**AGENDA**  
**CITY OF THE DALLES**  
**HISTORIC LANDMARKS COMMISSION**  
CITY HALL COUNCIL CHAMBERS  
313 COURT STREET  
THE DALLES, OREGON 97058  
*CONDUCTED IN A HANDICAP ACCESSIBLE MEETING ROOM*

**Wednesday, August 26, 2015**  
4:00 PM

- VI. **Public Hearings**
  - A. **Historic Landmarks Commission Application #148-15 (continued); Michiel Haley;**  
**Request:** To site and construct a 4-unit townhouse with rear parking. The townhouses will front Fourth Street and include traditional front entry elements and meet the design guidelines for the Trevitt’s National Historic District. Property is located at 402 West Fourth Street, The Dalles, Oregon, and is further described as 1N 13E 4 AA t.l. 3200. Property is zoned “CBC-1” – Central Business Commercial and is located in Trevitt’s National Historic District.

- B. **Historic Landmarks Commission Application #147-15; Alan and Bev Eagy;**  
**Request;** Approval of historic restoration of the Victor Trevitt House. Restoration to include kitchen and bathroom additions to the east and south sides of the structure that were previously removed; Property is located at 214 West Fourth Street, The Dalles, Oregon, and is further describe

FIGURE 1: EXISTING FEATURES AT PENTLAND HOUSE LOT

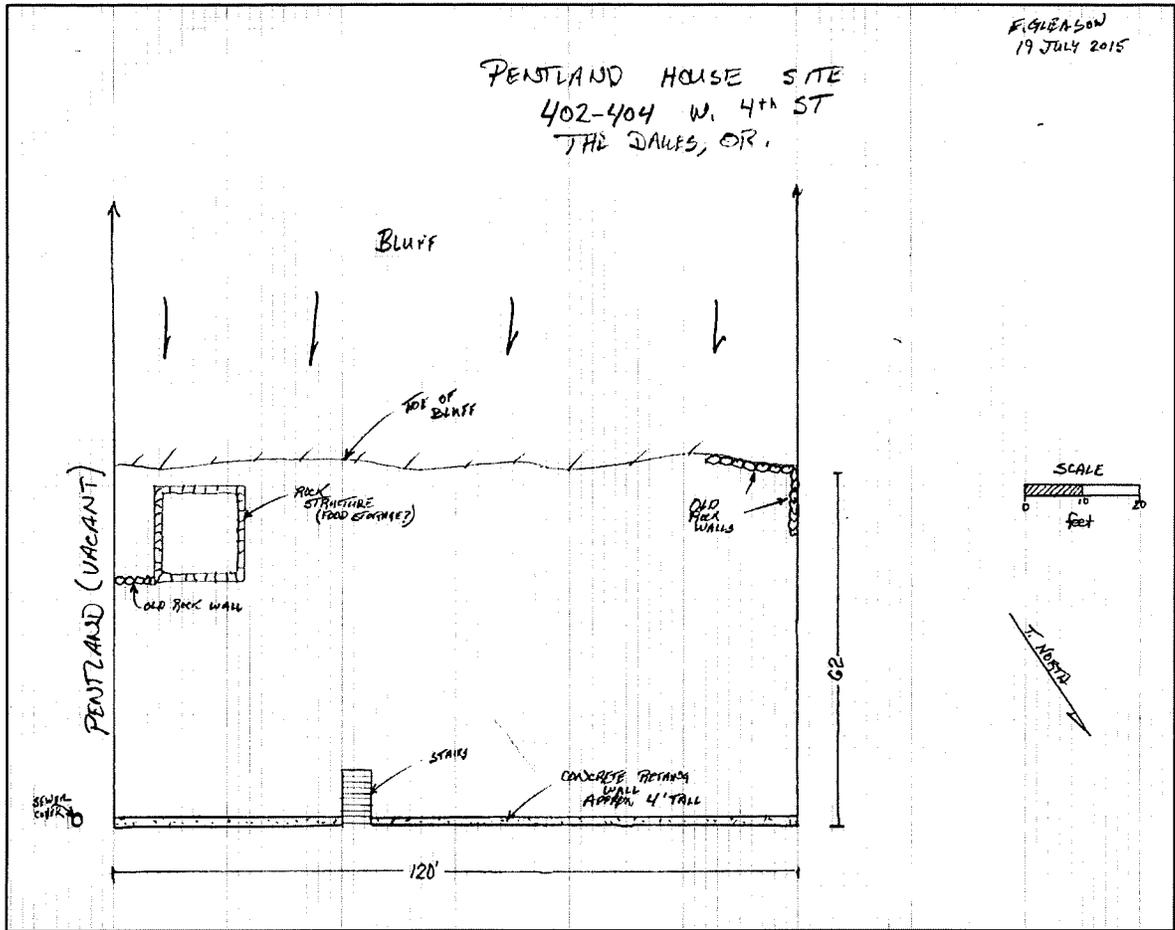
- The proposed site plans do not illustrate the rock structure, and it looks like it will have to be removed to accommodate the driveway. Is there a way that the new building and drive could be shifted to retain the rock structure? Could Pentland street be vacated here to allow more room for the drive, parking, or shifting the location of the new structure?

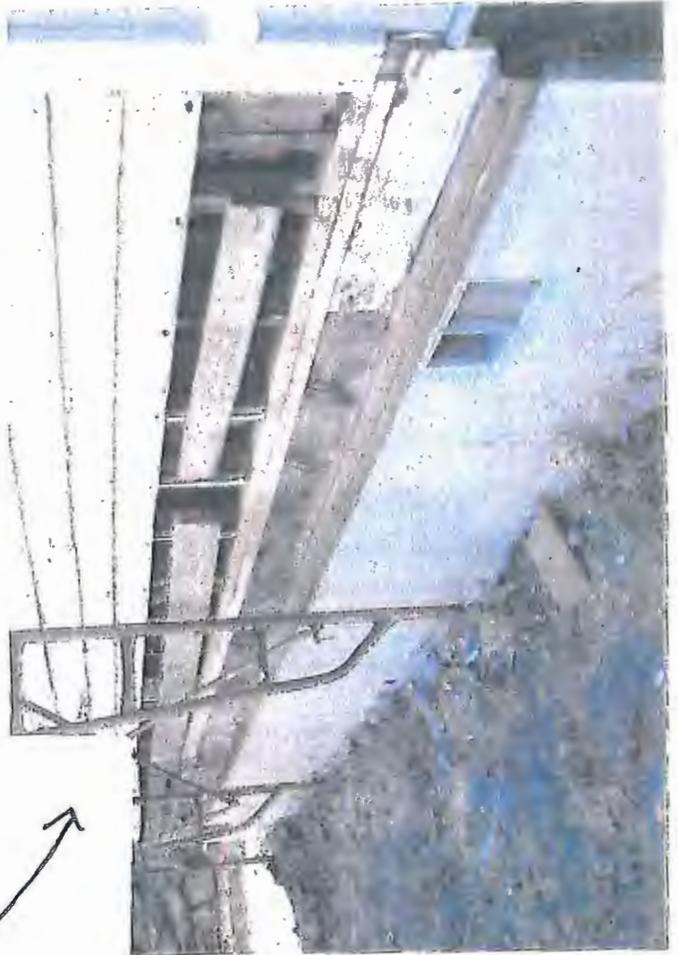
Restored safety rail  
needed here.

Lattice  
needed

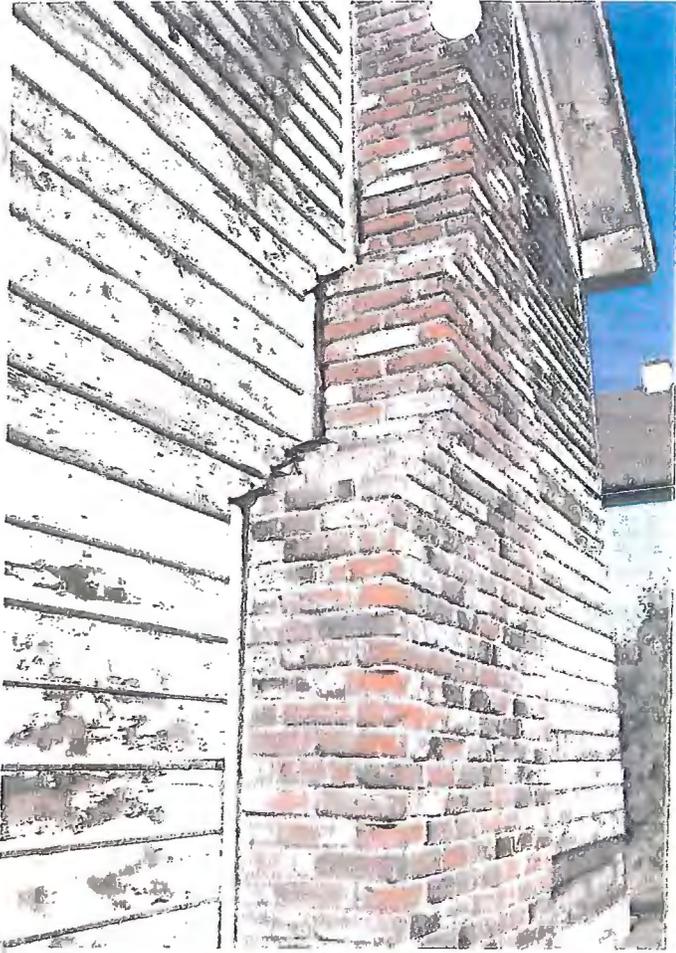
Siding  
Repair  
Needed

Chimney repair needed

Porch repair needed
